HISTORIC AND DESIGN REVIEW COMMISSION

March 15, 2017

HDRC CASE NO: 2017-097
ADDRESS: 2908 BROADWAY
LEGAL DESCRIPTION: NCB:3868 BLK:14 LOT: 1-5, & W IRR 7.5' OF S 260' OF 15' ALLEY, S 75'TRI
OF 9
ZONING: C-2
CITY COUNCIL DIST.: 2
APPLICANT: J Michael Berringer/Open Studio Architecture
OWNER: Fiesta Restaurant Group, LLC
TYPE OF WORK: Construction of an addition
REQUEST:

Re: 2908 Broadway Patio Addition

SCHEMATIC PERSPECTIVE

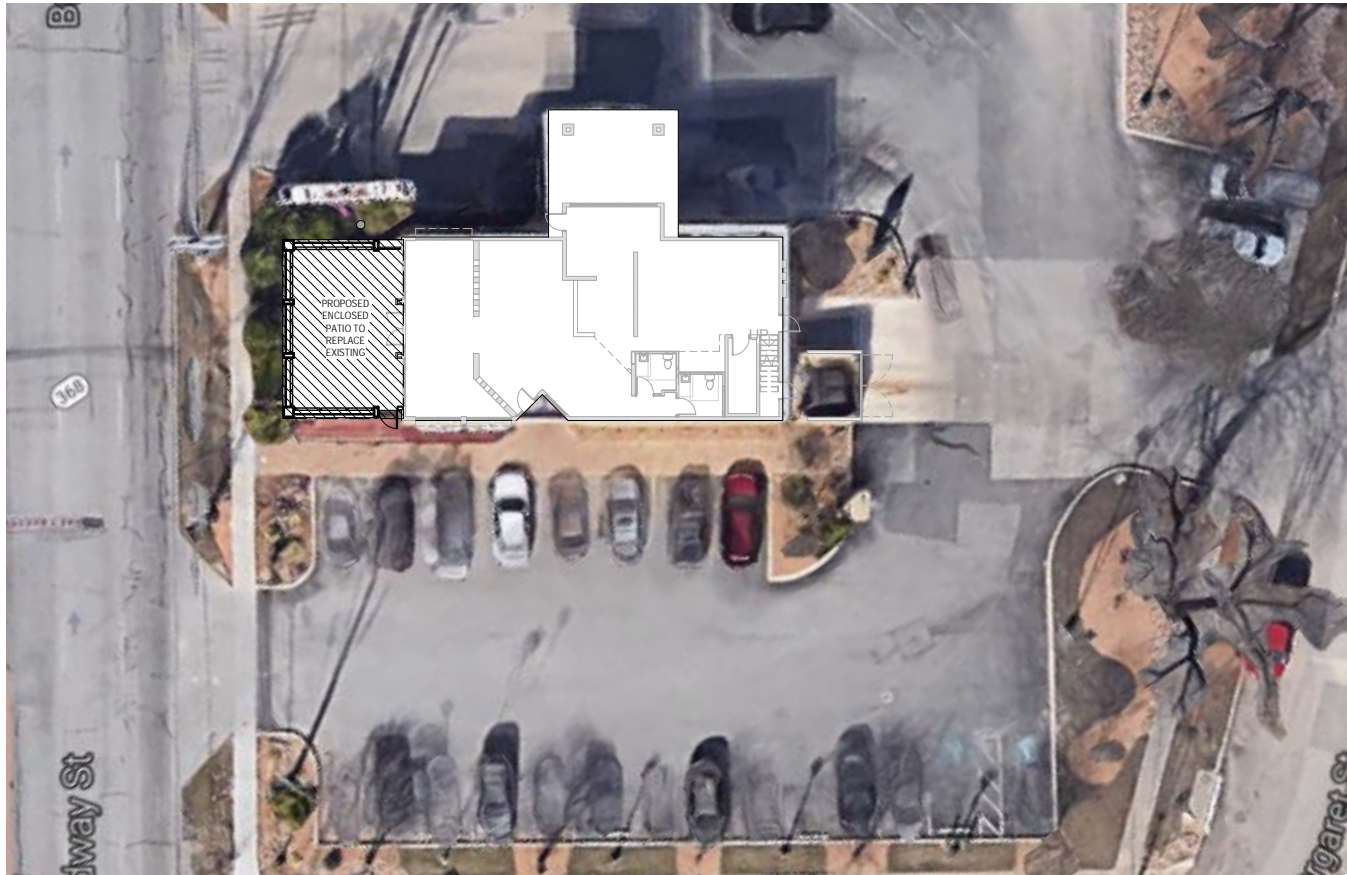
- e. MATERIALS – The applicant has proposed materials that include a storefront system to match that of the existing structure and stucco. The proposed materials match those currently found on site and are consistent with the UDC.

SCHEMATIC ELEVATIONS

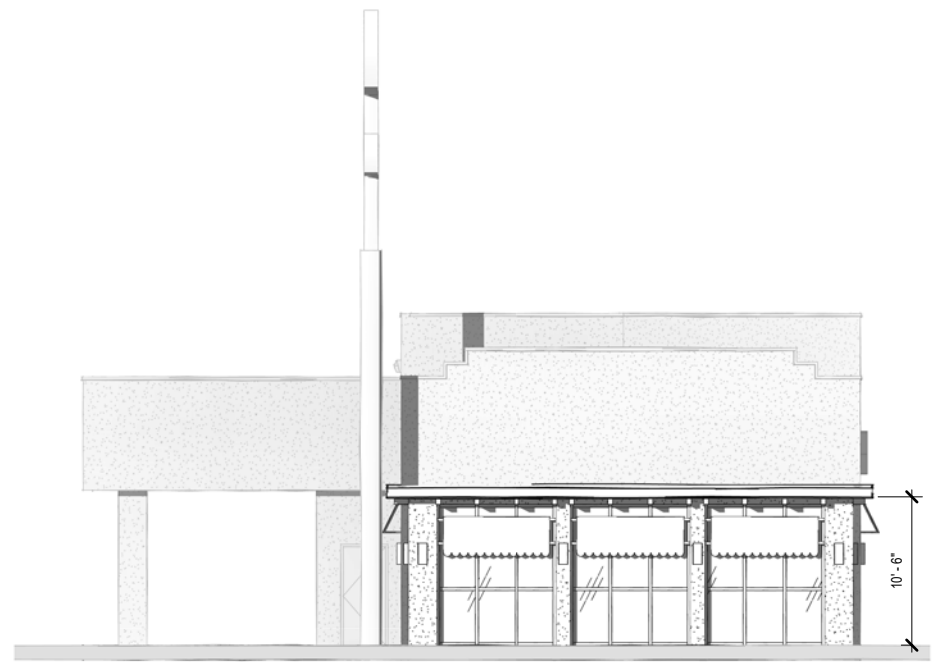
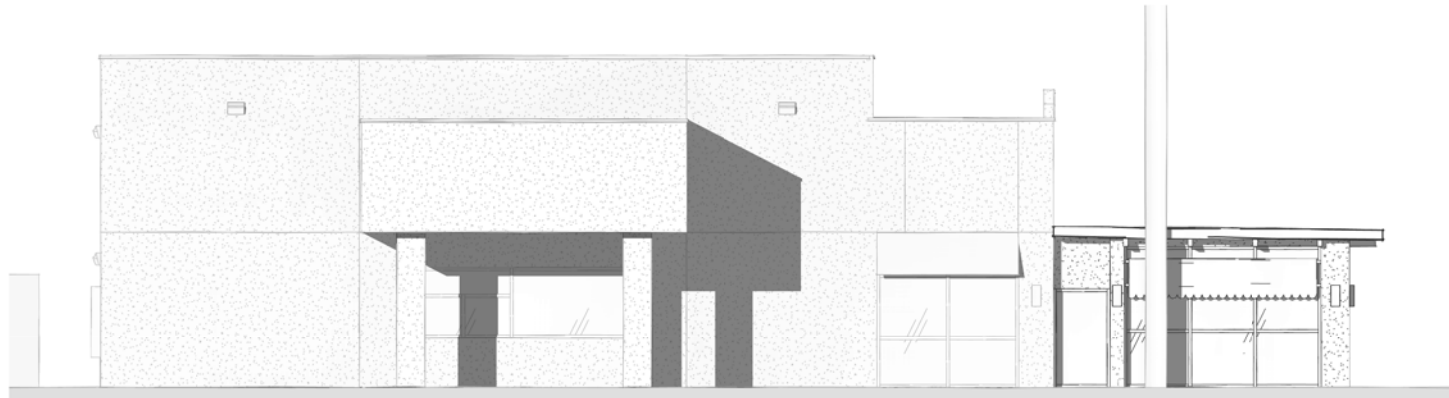
- d. ADDITION – The UDC Section 35-674 (b)(4) notes that a façade in RIO-3 that features more than thirty (30) feet in length should be divided into modules that express traditional dimensions. The applicant has incorporated bays of storefront systems with corresponding entrance canopies and alternating façade materials. This is consistent with the UDC.
